From: [Rachel Zwillinger](#)
To: EIR-EIS-Comments@SitesProject.org
Cc: aforsythe@sitesproject.org; yking@usbr.gov
Subject: Comments on Sites RDEIR/SDEIS
Date: Friday, January 28, 2022 8:21:29 AM
Attachments: [NRDC et al Comments on Sites RDEIR-SDEIS 1.28.22.pdf](#)
[Exh. 1 to NRDC et al Comments on Sites RDEIR-SDEIS.pdf](#)
[Exh. 2 to NRDC et al Comments on Sites RDEIR-SDEIS.pdf](#)
[Exh. 3 to NRDC et al Comments on Sites RDEIR-SDEIS.pdf](#)

**RE: Comments on Sites Reservoir Revised Draft Environmental Impact Report/
Supplemental Draft Environmental Impact Statement (RDEIR/SDEIS)**

On behalf of the Natural Resources Defense Council, Defenders of Wildlife, San Francisco Baykeeper, The Bay Institute, Planning and Conservation League, Restore the Delta, Northern California Council of Fly Fishers International, California Sportfishing Protection Alliance, Friends of the River, Golden West Women Flyfishers, Institute for Fisheries Resources, Pacific Coast Federation of Fishermen's Associations, Sierra Club California, Save California Salmon, and Golden State Salmon Association, we are writing to submit comments on the November 2021 Sites Reservoir Revised Draft Environmental Impact Re

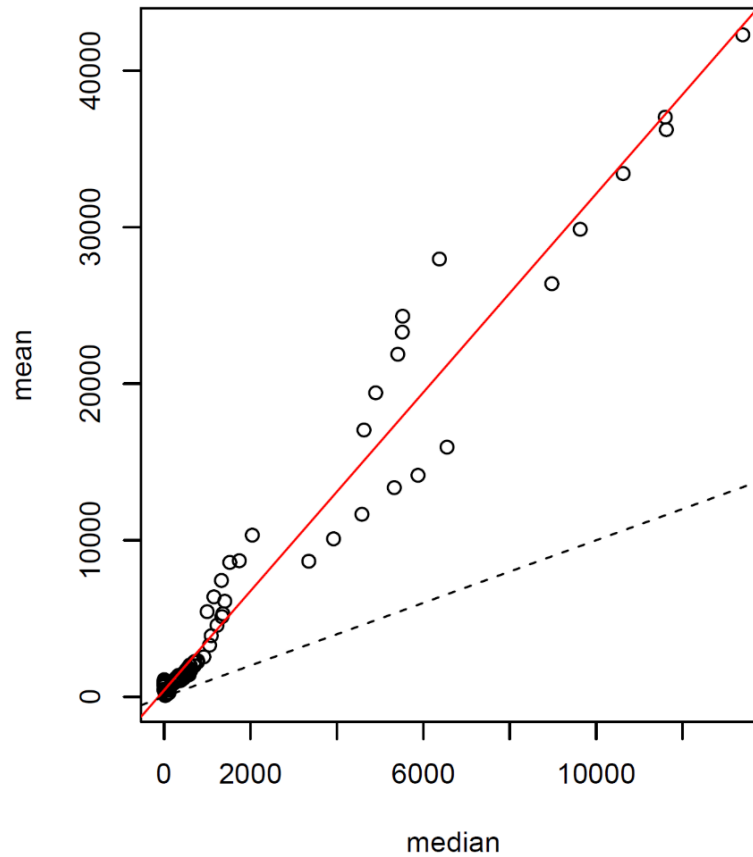
Furthermore, it is not appropriate statistically to compare medians (or differences between medians) to estimates of variance around the mean (e.g., standard error); the ITP makes this mistake (CDFW 2019a e.g., footnote 2 of Table 4-10 at p. 4-59³), as do all the previous applications of the ICF/MWD R-script that I have reviewed. This error is particularly misleading when medians and mean values are widely divergent, as they are in the case of the R-script's projections of LFS abundance (Figure 1). If the median values are much smaller than the mean values (as they are in this case), then dividing the median by the error around the mean will erroneously suggest that the difference in medians is "small" relative to the variance (see, for example, CDWR 2019a e.g., at p. 4-57).

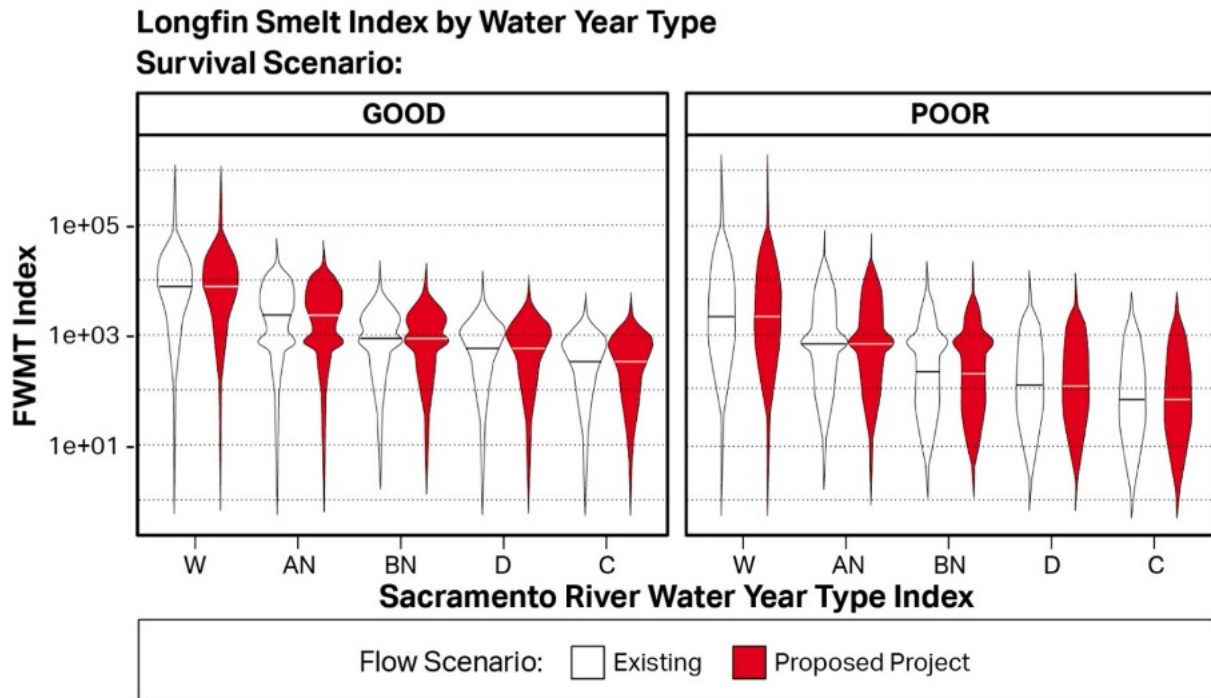
The R-script compares alternatives based on modeled median outcomes of each operational alternative within hydrological year-types. Comparing the predicted median RPS or median predicted abundance index under different flow alternatives is statistically questionable as is comparing those results within water-year type. The median is not a stable metric in this context; it likely represents a single year in each replicate and in each alternative*year-type combination. This single year may vary across replicates and alternative*year-type combinations, so comparing medians across alternatives does not necessarily provide a valid comparison of expected population performance in any given year. Also, the median is intended to reflect the central tendency (“average” or “typical” value) of a population. But, median abundance does not represent a “typical” result when the population is known to be declining. The SFE LFS population has declined by orders of magnitude over the past several decades and is very responsive to Delta outflows, which are highly variable; there is no “typical” RPS or abundance in this situation, the median depends on the starting value, the length of the period studied, and the sequence of Delta hydrologies.

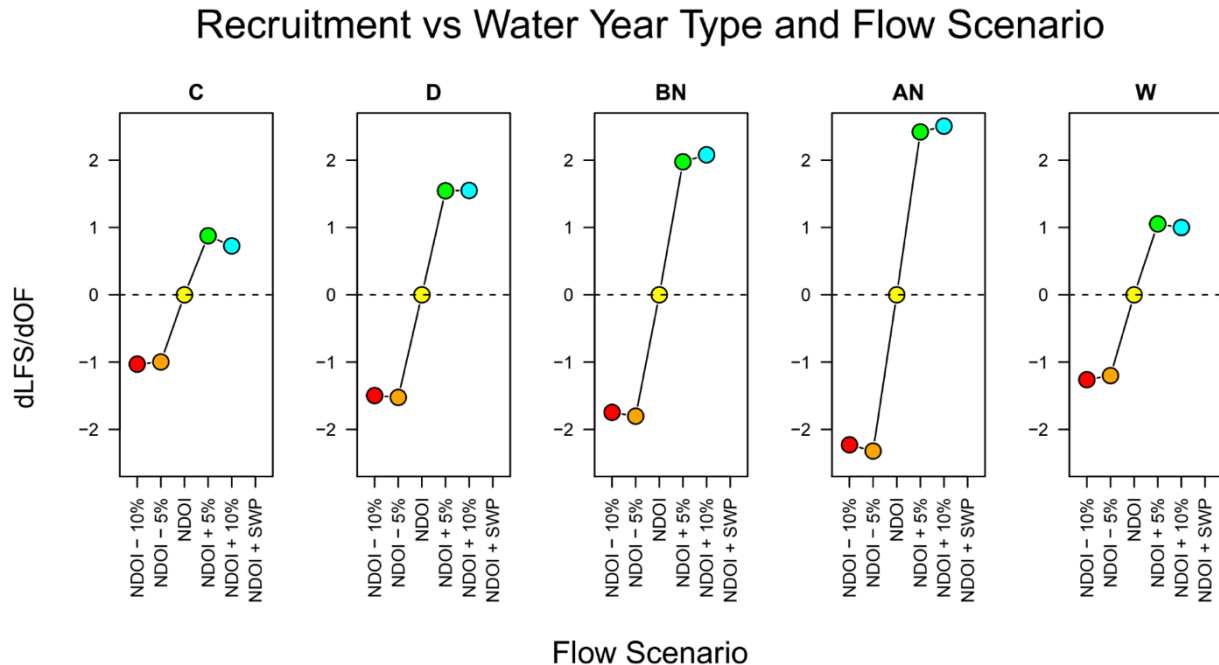
Scaling the differences among alternatives in water-year median recruitment as a percentage change from median recruitment under the “NDOI” scenario allows one to see the relative magnitude of the effect of different alternatives; this is the essence of what it means to compare alternatives. When the erroneous error estimates described above are removed from the graphics, the R-script output reveals that the operational alternatives will produce large proportional changes in recruitment (Figure 4, bottom panel). In fact, the proportional changes in recruitment are larger than the proportional changes in flow represented by the operational alternatives (Figure 5). In other words, the population response to changing Delta outflow is disproportionately high. The precise median values generated by the R-script are unimportant in this context (and, as described above, the median is a suspect metric); what is relevant is that median recruitment is higher than the status quo under alternatives with higher Delta outflows (NDOI + 5%, NDOI +10%, and NDOI + SWP) and lower than the status quo in alternatives with lower flows. Predicted increases in median recruitment under the NDOI + SWP alternative (Net Delta Outflow equals actual NDOI for a given year plus SWP exports that year) as compared to NDOI alone were 9%, 36%, 25%, 30%, and 34% in wet⁵, above normal, below normal, dry, and

higher in the “NDOI minus 5%” flow scenario (Figure 5). This is a large increase to the probability of extinction, which is already very high.

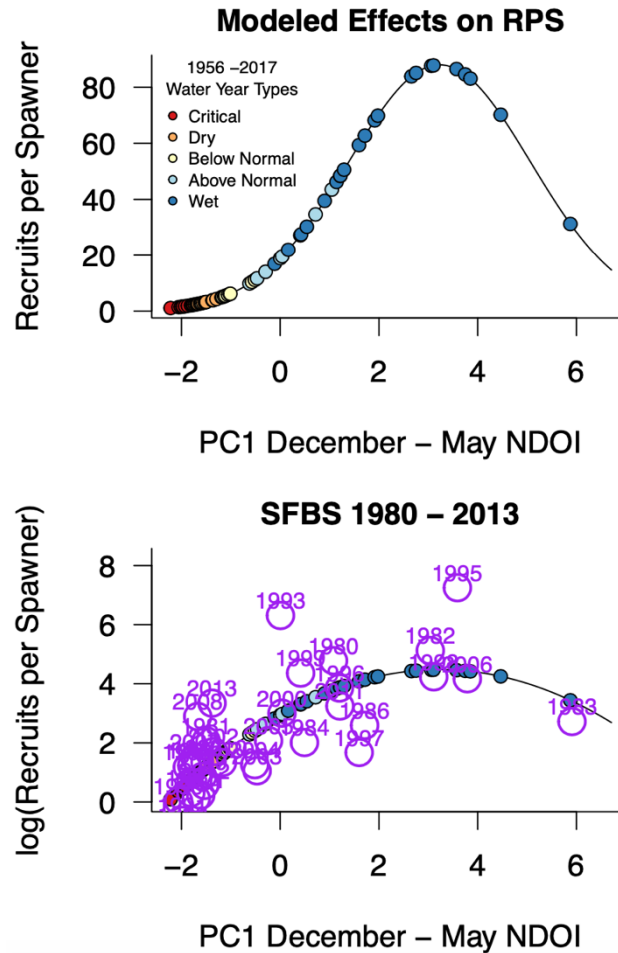
- (2) The N&R model describes the relationship between recruits-per-spawner (RPS) and Delta outflow as a quadratic equation -- this causes RPS to decline at extremely high Delta outflows (Figure 6). As a result, the model sometimes predicts declines in abundance during very wet years and declines for operational alternatives that increase Delta outflows in very wet years (e.g., in 2017). But empirical data reveal high variance of RPS at high flows and the decision to use a quadratic RPS-flow relationship (as opposed to a linear relationship, for example) is driven by only one year in the data set (1983; Figure 6, lower panel). Again, Nobriga and Rosenfield (2016) could not investigate the best shape of the RPS-flow relationship because of limited data under very high flow conditions. Correcting or at least describing this function (e.g., by bounding it with results of a sensitivity analysis) will improve understanding of how the population behaves under different flow scenarios.
